MORGANTOWN BOARD OF ZONING APPEALS

STAFF REPORT

CASE NO: COMBINED REPORT
V14-44, V14-45, V14-46, V14-47, V14-48 and V14-49
Highland Park Square / 502 Stewart Street

PLANNING AND ZONING CODE CONFORMITY REPORT

2 SITE PLAN
1/16" = 1'-0"

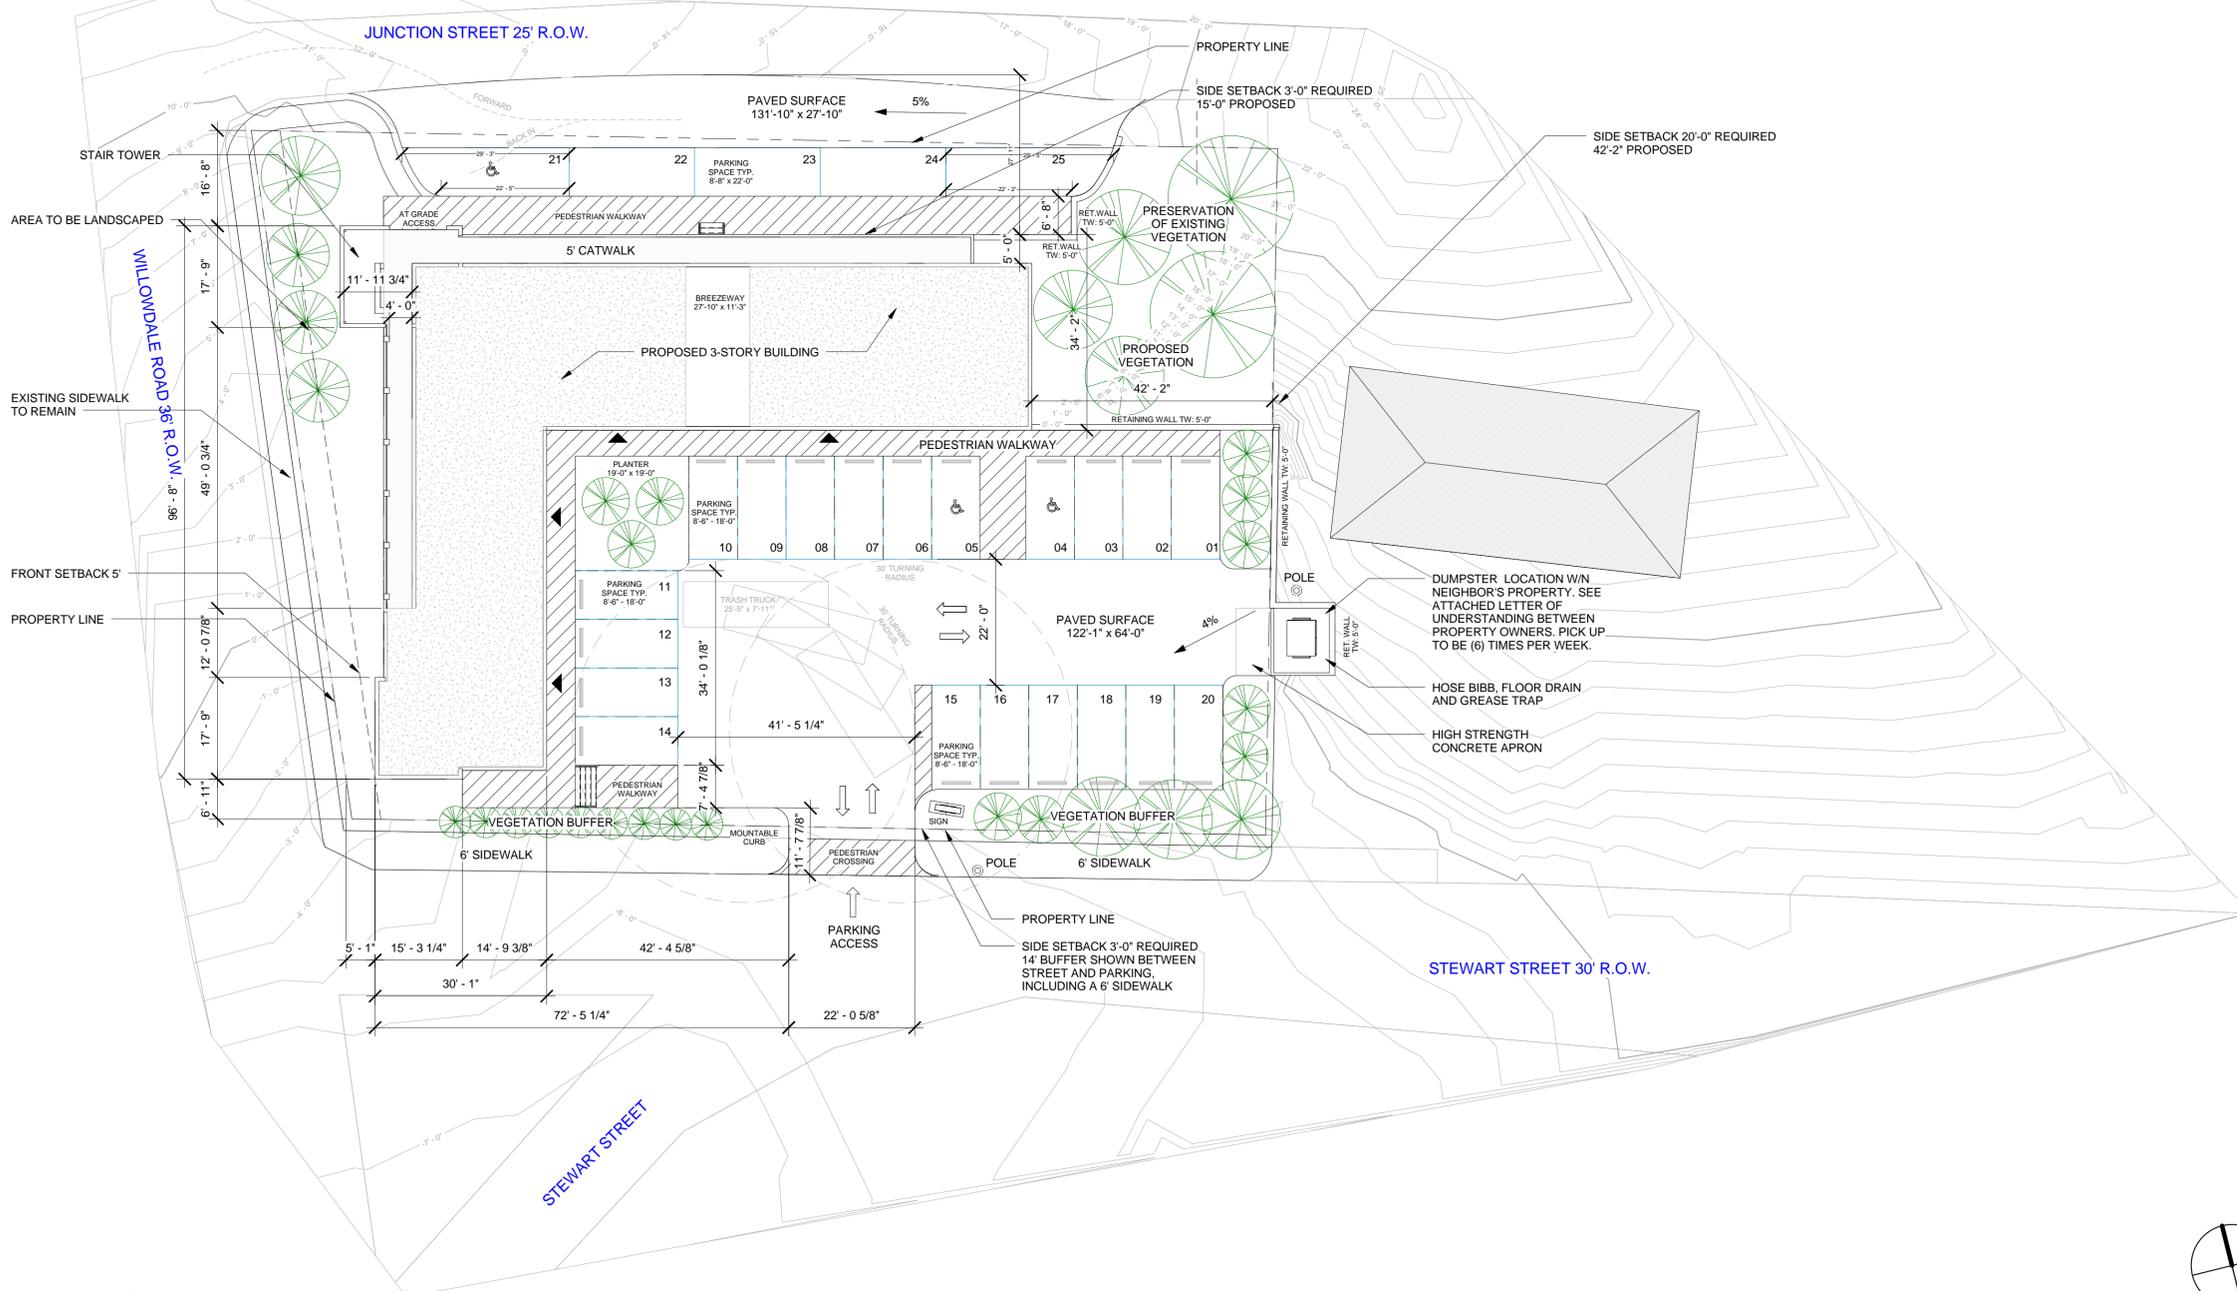
2. A TEN-FOOT WIDE BUFFER SHALL BE PROVIDED FOR THE LENGTH OF ANY PARKING AREA ABUTTING THE STREET. A LANDSCAPE/ SIDEWALK BUFFER HAS BEEN LOCATED BETWEEN THE PARKING LOT AND STEWART ST. REFER TO THE DRAWING FOR THE DIMENSION OF THE BUFFER OUTSIDE OF THE PROPERTY LINE. THE PLAN ILLUSTRATES A LANDSCAPE BUFFER ALONG STEWART STREET RANGING FROM TWO FEET TO SIX FEET MEASURED FROM THE PROPERTY BOUNDARY TO EDGE OF PARKING LOT PAVEMENT. THE FUNCTIONAL BUFFER IS WIDER AND RANGES FROM FIVE TO EIGHT FEET MEASURED FROM THE BACK OF THE PROPOSED SIX-FOOT SIDEWALK TO THE EDGE OF THE PARKING LOT. THIS ADDITIONAL WIDTH IS PROVIDED WITHIN THE PUBLIC R.O.W. THE DEVELOPMENT TO THE SIX-FOOT SIDEWALK IS AT THE EXISTING EDGE OR CURB LINE OF THE STEWART STREET PAVEMENT RATHER THAN BEGINNING (BACK OF SIDEWALK) AT THE PROPERTY BOUNDARY AS IS CUSTOMARILY DESIRED. THE PROPOSED SIDEWALK IS ALONG STEWART ST. THIS BUFFER HAS BEEN OMITTED AT JUNCTION ST. DUE TO THE PARALLEL PARKING ARRANGEMENT. THE PROPOSED BUILDING ABUTS A RESIDENTIAL-USE PROPERTY. A 10' LANDSCAPE BUFFER DOES NOT EXIST AT THIS LOCATION, AND THEREFORE REQUIRES A VARIANCE. TERMINAL ISLANDS REQUIRED ADJACENT TO SPACES 14 AND 15 HAVE NOT BEEN PROVIDED. QUOTED LANGUAGE FROM CONFORMITY REPORT 2014917

② WEST ELEVATION
 1/16" = 1'-0"

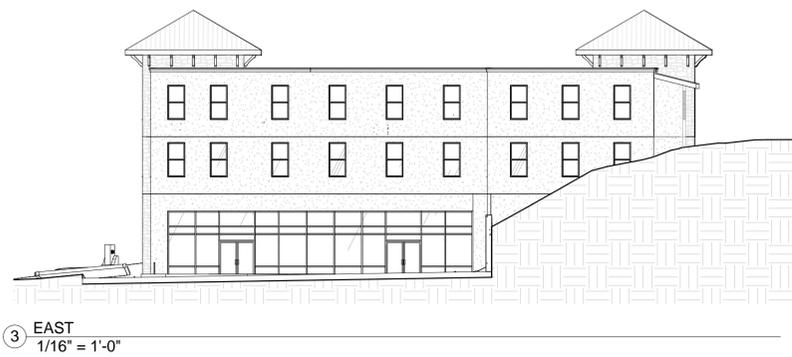
Article 1345.07(D)(5) – Variance relief is required to develop a front façade with a fenestration ratio of 15.8% rather than 60%.

(D) Configuration.
N	(D)(1) Two wall materials may be combined horizontally on one façade. The heavier material shall be below and should not extend above the first floor. The alternate cladding design requires variance relief.
N/A	(D)(2) Skylights shall be flat (non-bubble).
Y	(D)(3) Street level windows shall be non-tinted. The glazing material schedule provided on Sheet A07 is clear glass.
Y	(D)(4) Windows shall be square or vertical proportion, unless they are transom windows.
N	(D)(5) Front façade shall have a fenestration ratio of not less than sixty (60) percent. The elevation of the front façade illustrates a fenestration ratio of 15.8%, which requires variance relief.
